SERVICE INFORMATION LETTER

SERVICE INFORMATION LETTER NO. 0187
Revision 1

1. SUBJECT: Universal Block: P/N 28-14117-11
2. MODEL: F-28A, F-28C, F-28C-2, F-28C-2R, F-28F, F-28F-R, 280, 280C, 280F, and 280FX
3. EFFECTIVITY: All S/N having received or are scheduled for T-T strap modification via STC SR03465CH; Excludes F-28F S/N 832 and subsequent and 280FX S/N 2147 and subsequent.
4. BACKGROUND:

Figure 1. Universal Block Inspection and Rework Criteria

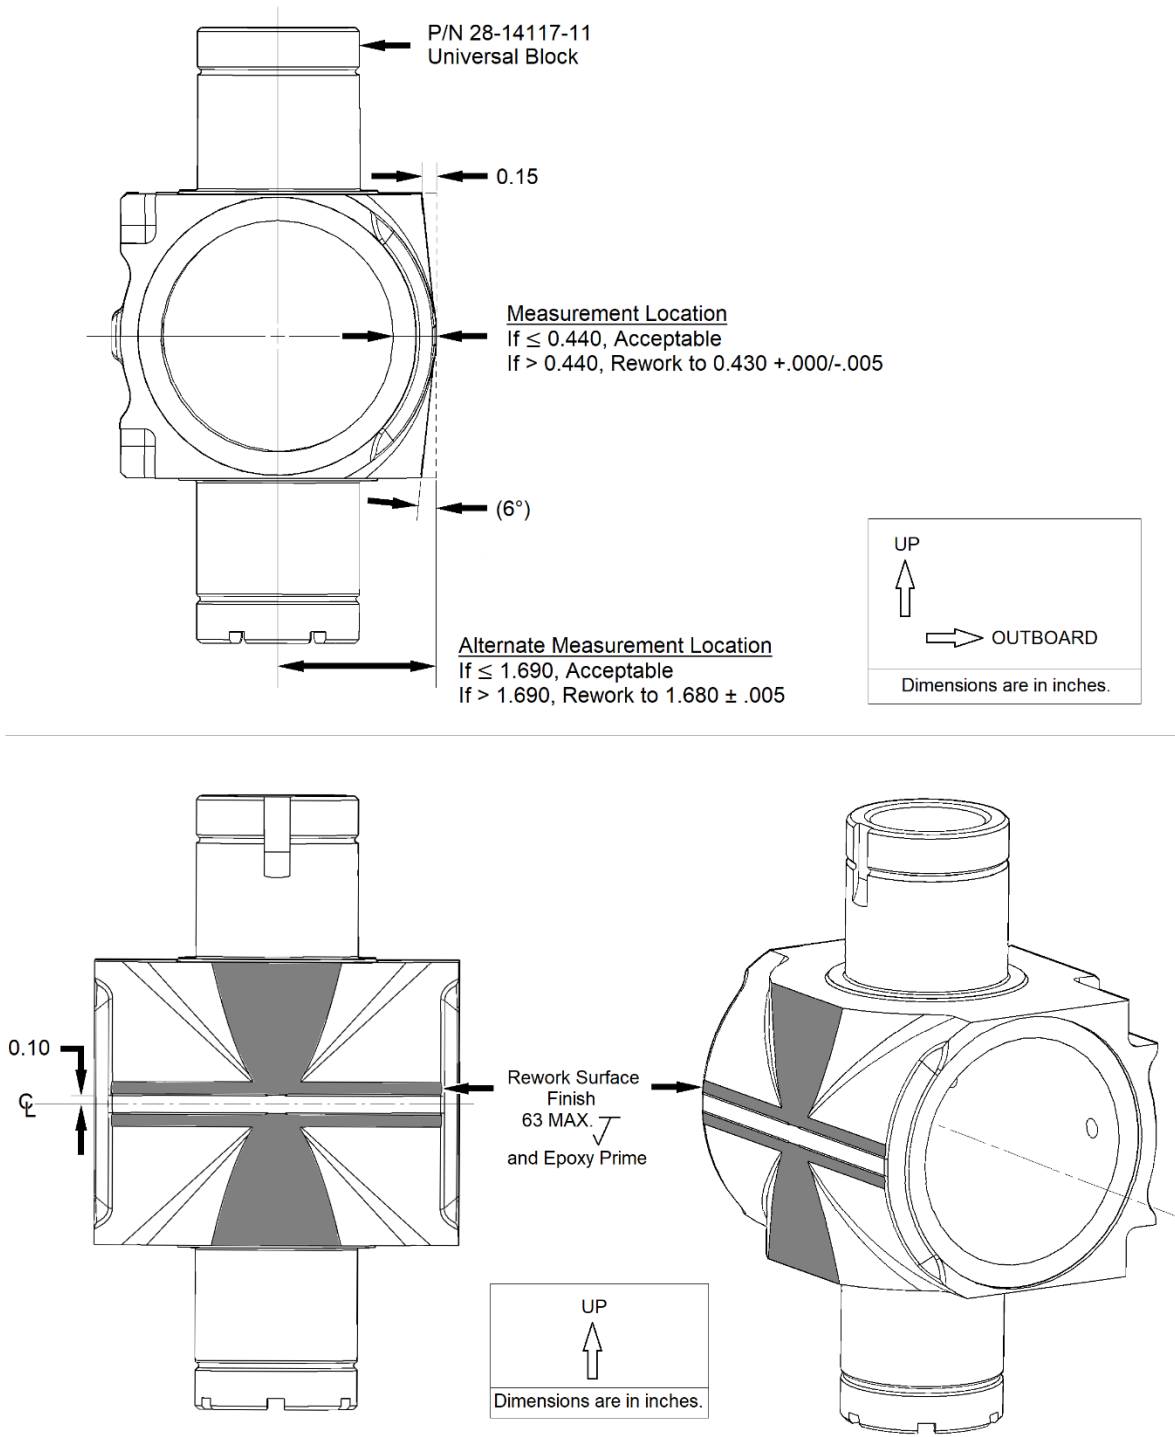
Revision 1 of this SIL introduces a modified U-block rework design. (Enstrom had received a report of an instance that contact was still evident after installing a U-block that was reworked to the previous revision of this SIL.) This design matches the current production configuration.

6.2.1 Measure the cross-section distance from the flapping pin bore surface to the outside surface of the universal block (Figure 1). (An alternate measurement location, flapping pin bore centerline to outside surface, is also acceptable for determining if rework is necessary. See Figure 1.)

6.3 If the width is greater than 0.440, the universal block surface must be reworked per the parameters depicted in Figure 1.

6.3.1 Mill the flats and chamfer the outboard top and bottom edges as shown in Figure 1 (63 maximum surface finish).

6.2.2 If the width is less than or equal to (\leq) 0.440, no further action is required.

6.3.2 Epoxy prime the reworked surface. (Epoxy primer may be procured from a local source.)
